**COLORADO DIVISION OF RECLAMATION, MINING AND SAFETY**  
**MINERALS PROGRAM INSPECTION REPORT**  
**PHONE: (303) 866-3567**

<b>MINE NAME:</b> Arkins Park Quarries	<b>MINE/PROSPECTING ID#:</b> M-1985-212	<b>MINERAL:</b> Sandstone	<b>COUNTY:</b> Larimer
<b>INSPECTION TYPE:</b> Monitoring	<b>INSPECTOR(S):</b> Michael A. Cunningham	<b>INSP. DATE:</b> December 10, 2015	<b>INSP. TIME:</b> 09:00
<b>OPERATOR:</b> ARKINS PARK STONE CORPORATION	<b>OPERATOR REPRESENTATIVE:</b> Chantea Honer	<b>TYPE OF OPERATION:</b> 112c - Construction Regular Operation

**INSPECTION TOPIC:** Off-site Damage

# Arkins Park Quarries

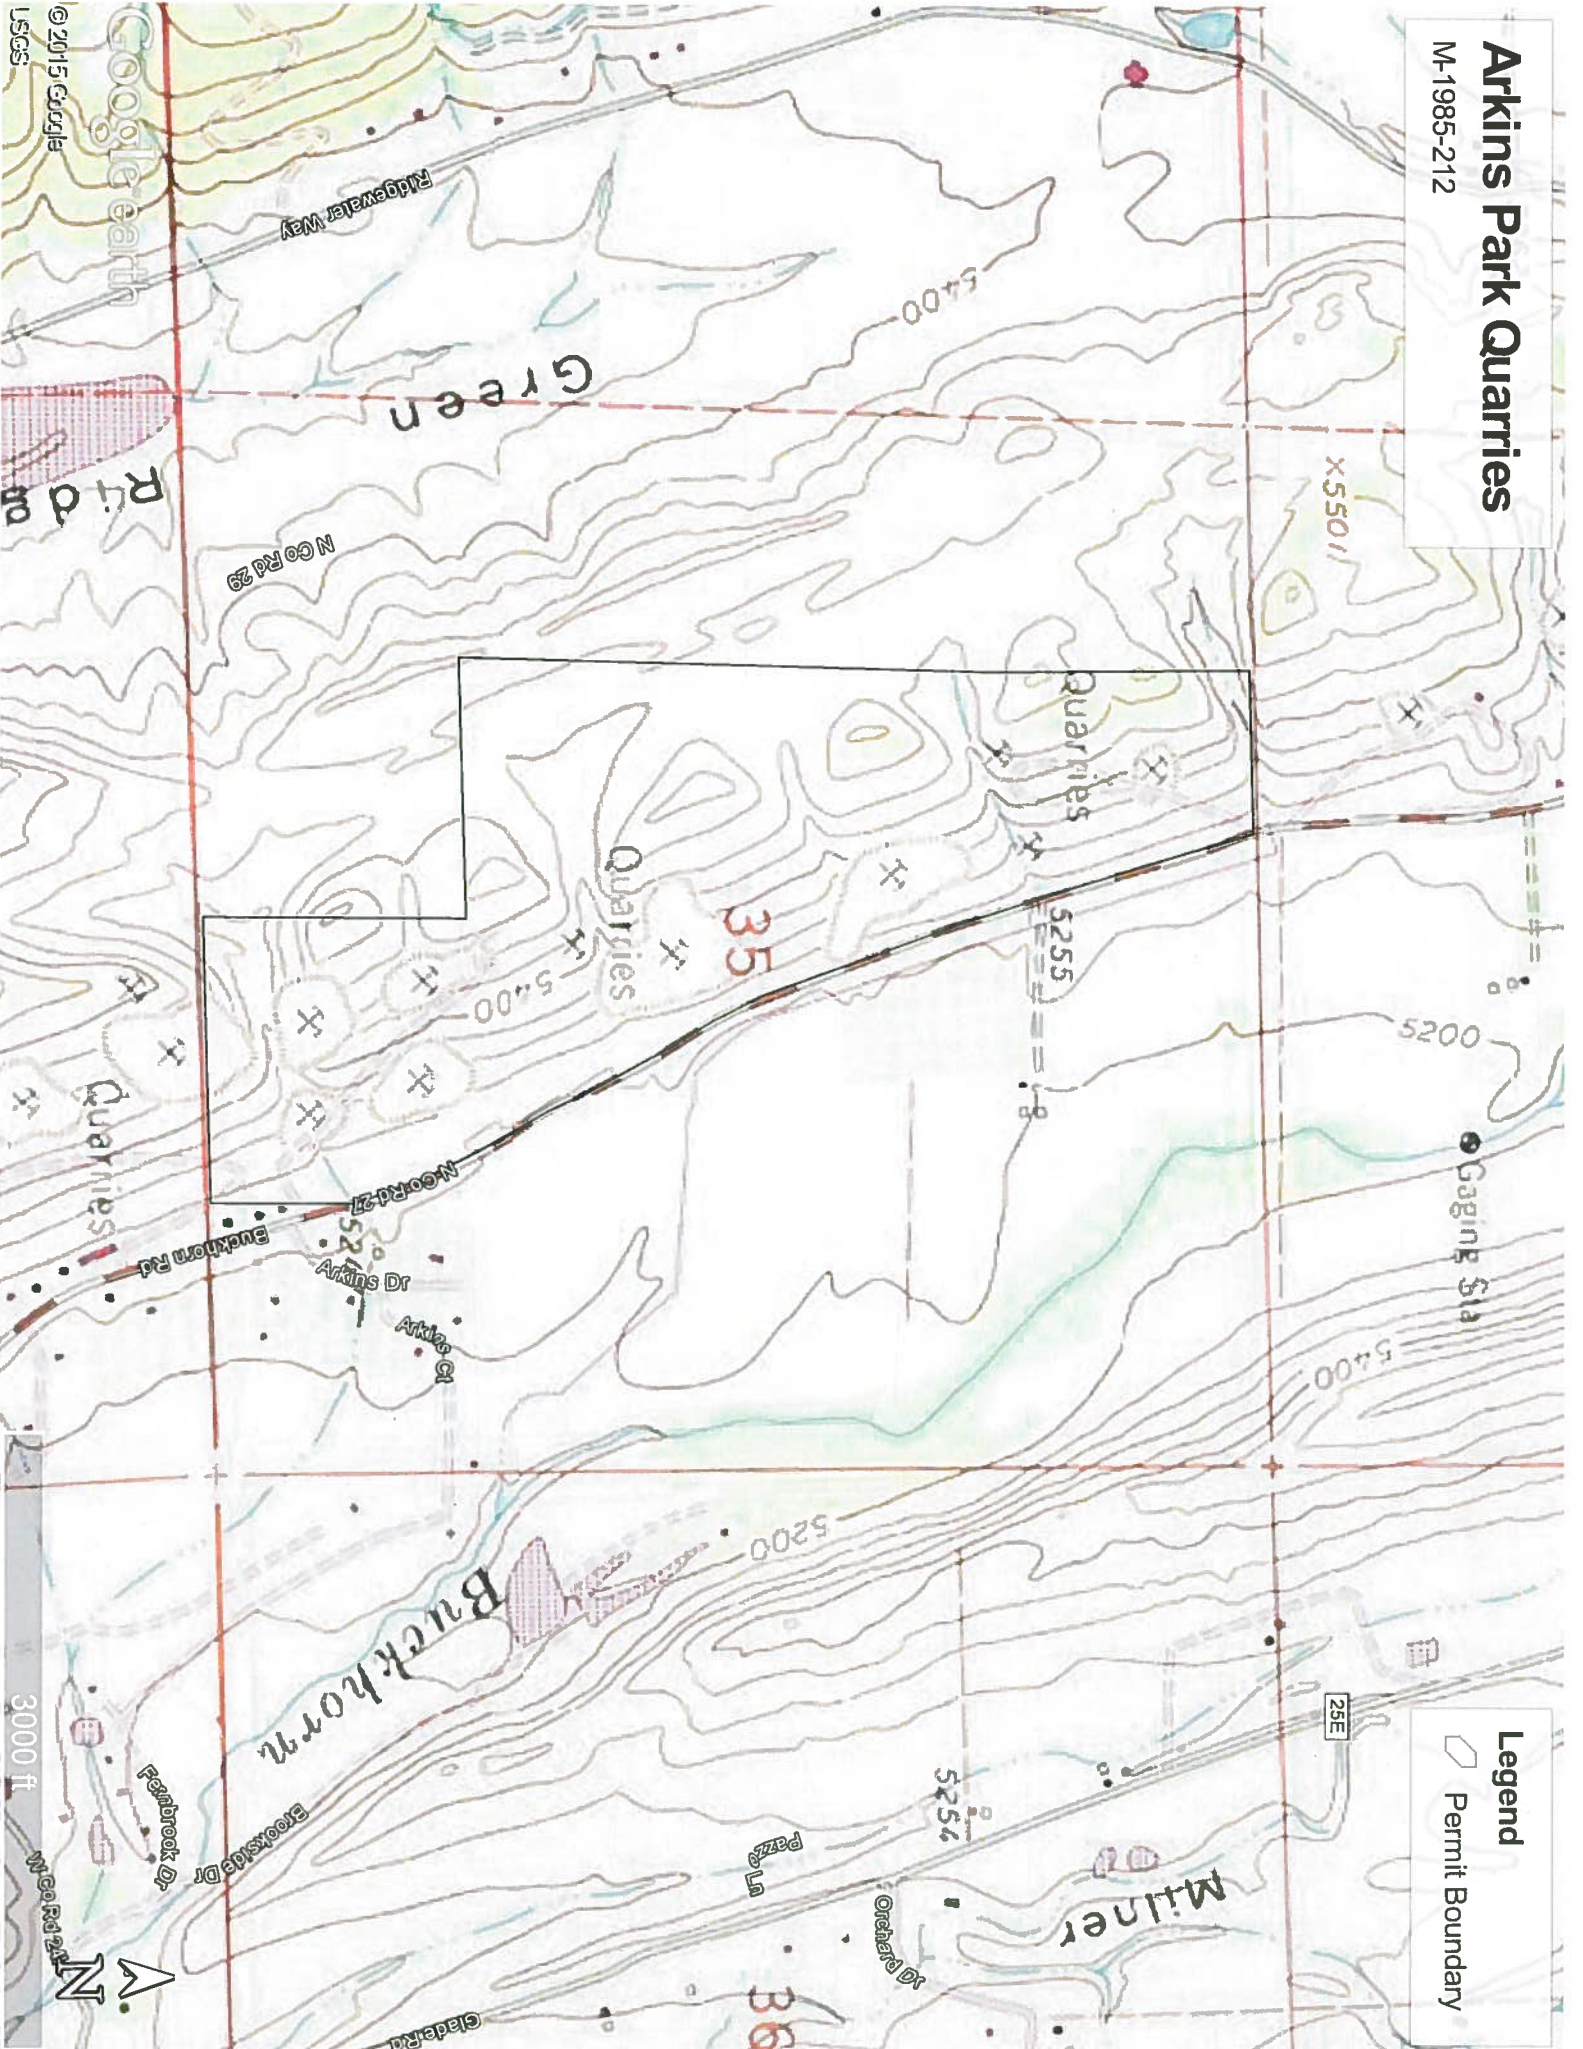
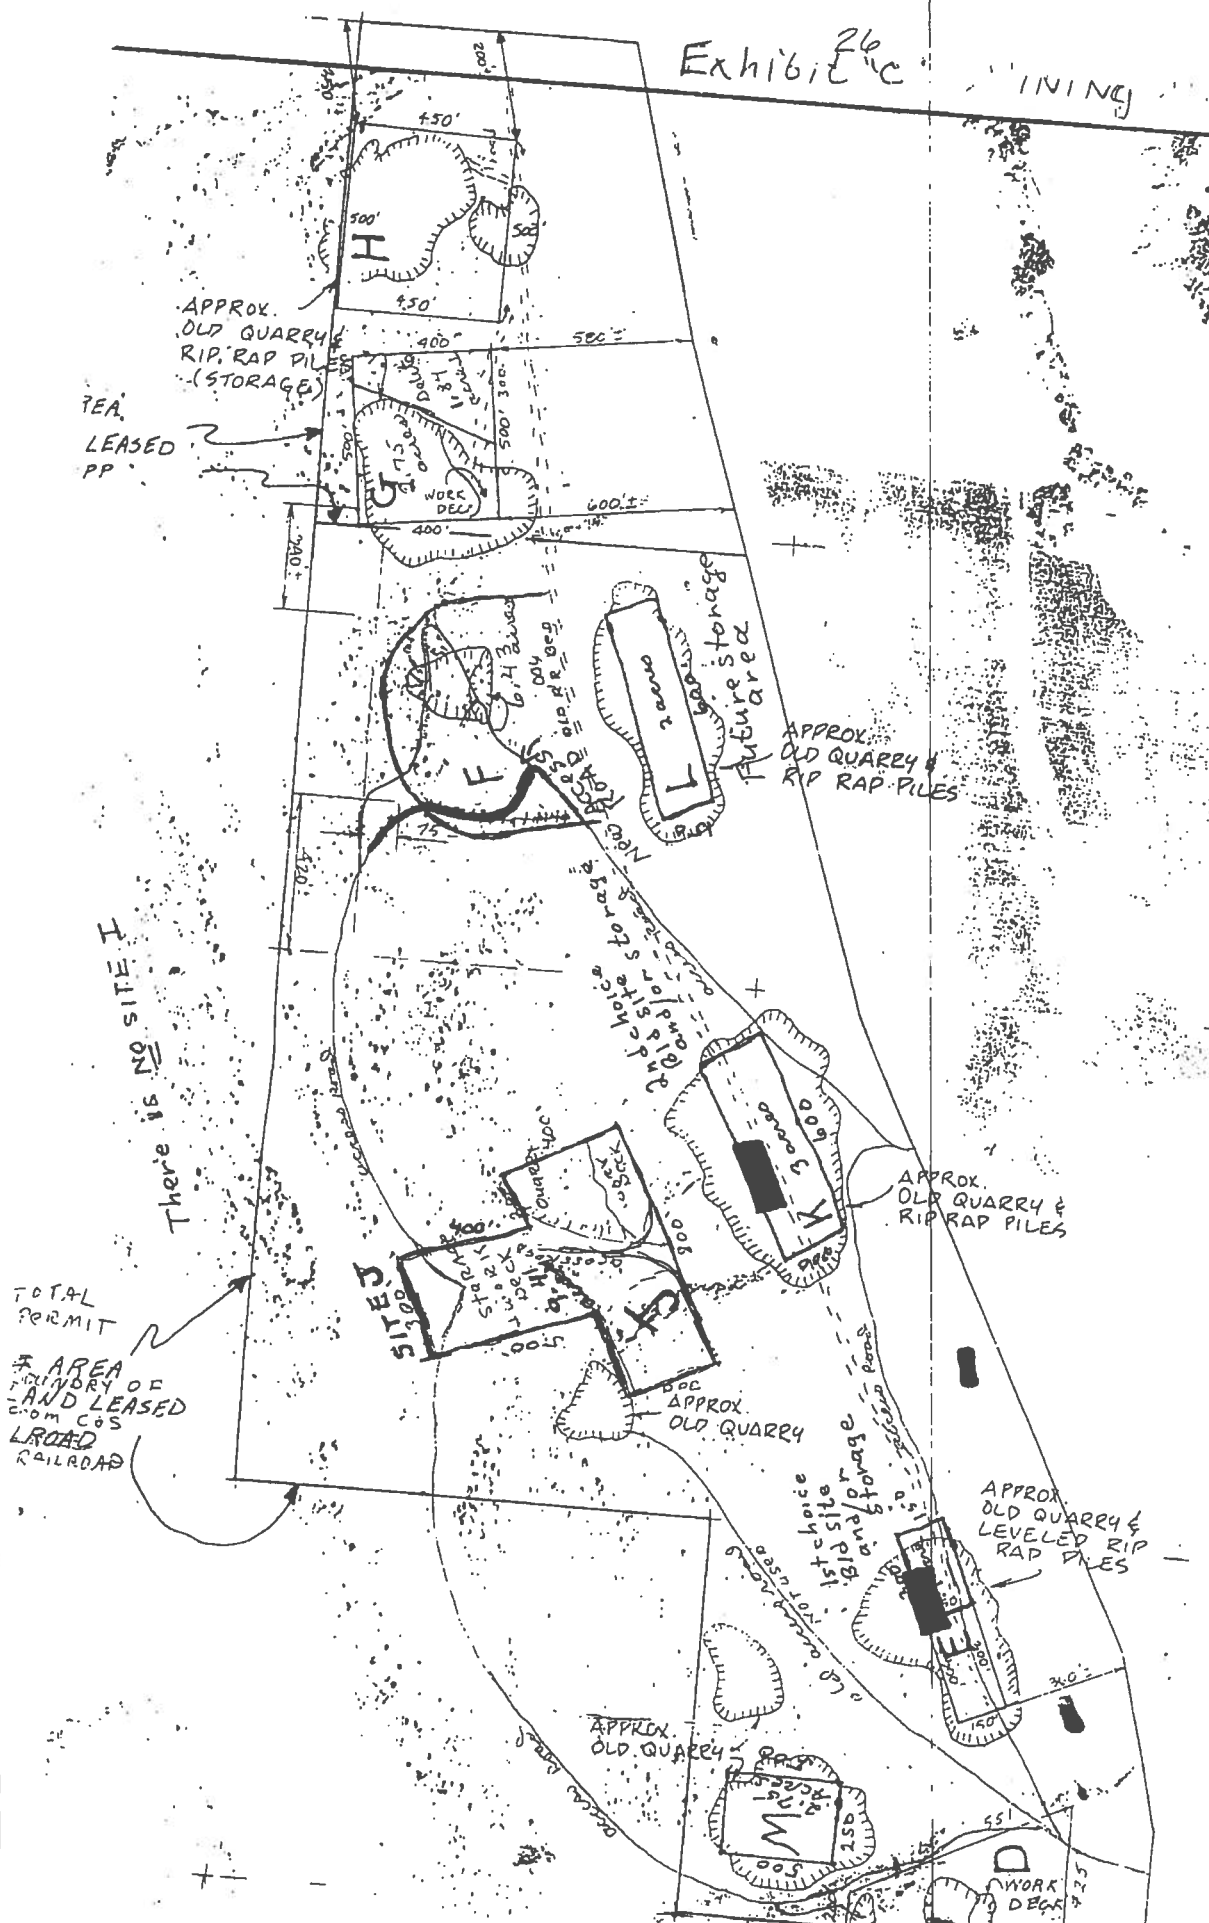
**PROBLEM/POSSIBLE VIOLATION:** Problem: The Division has reason to believe, based on a review of Mining Plan Maps and aerial photographs, that the Operator may have affected land outside of the permit boundary. This is a problem pursuant to C.R.S. 34-32.5-116(4)(i) for failure to protect areas outside of the affected land from slides or damage occurring during the mining operation and reclamation.

Following the inspection, the Division utilized Google Earth Pro to overlay the permit boundary onto an aerial photograph of the Arkins Park Quarry. The aerial photograph was taken on June 19, 2014 and is considered to be representative of current site conditions. The permit boundary was recreated by referencing Exhibit C - Mining Plan Map which was submitted under Conversion No. 2 (approved August 28, 1986) as well as Exhibit C - Mining Plan Map submitted under Amendment No. 2 (approved April 21, 1994). The approved Mining Plan Maps depict the permit boundary on a USGS 7.5 minute topographic map. Utilizing historical topographic maps in Google Earth Pro, the Division was able to draw the permit boundary using the contour lines as reference points. Upon review of the completed maps, the Division believes a portion of the western permit boundary is incorrectly delineated in the field. As a result, the Division has reason to believe that approximately 16.3 acres of land have been affected outside of the approved permit boundary. Failure to protect areas outside of the affected land may result in a possible violation. However, the Division will afford the Operator an opportunity to demonstrate that the currently delineated permit boundary accurately encompasses the 177 acre permit area.

The Division has included the two maps created in Google Earth Pro, one depicting the permit boundary over an aerial photograph of the site and the other depicting the permit boundary over a topographic map. In addition, copies of the above referenced Mining Plan Maps have been enclosed with this report. **This matter has been cited as a problem and will require corrective action by the Operator. Please see the first page of this report for additional information.**

**CORRECTIVE ACTIONS:** The Operator shall conduct a professional survey of the permit boundary, as it is currently delineated, and shall provide the Division with a map depicting the surveyed permit boundary on or before the corrective action date.
